**Before the  
Federal Communications Commission  
Washington, DC 20554**

Petition For Reconsideration and Emergency Request For Immediate Relief

The Independent MultiFamily  
Communications Council (IMCC)  
(formerly ICTA)

This Petition for Reconsideration and Request for Emergency Relief addresses FCC 02-317, Second Order on Reconsideration.

**Figure 1: FCC 18 GHz Antenna Pattern**

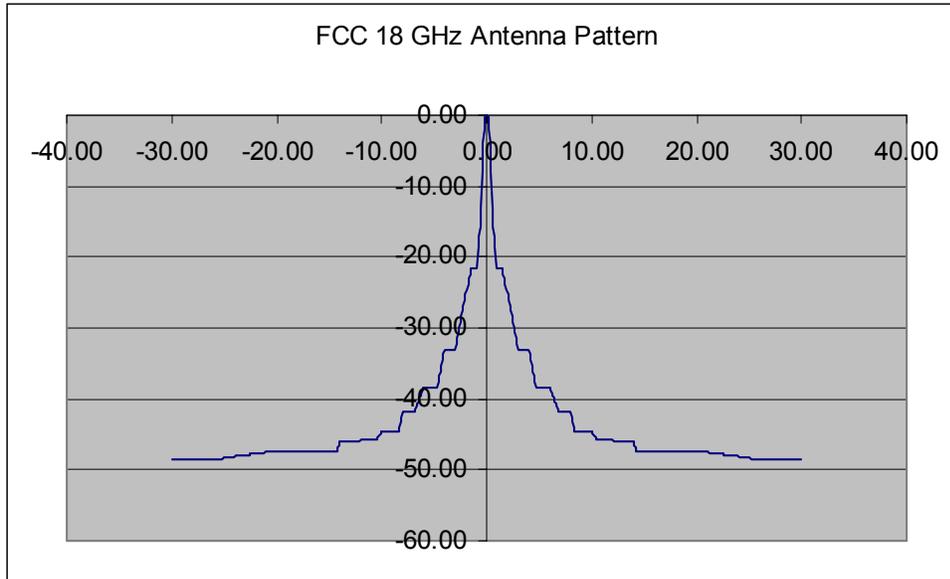
Figure 1 shows the discrimination pattern of the 18 GHz antenna used in the FCC's PCO
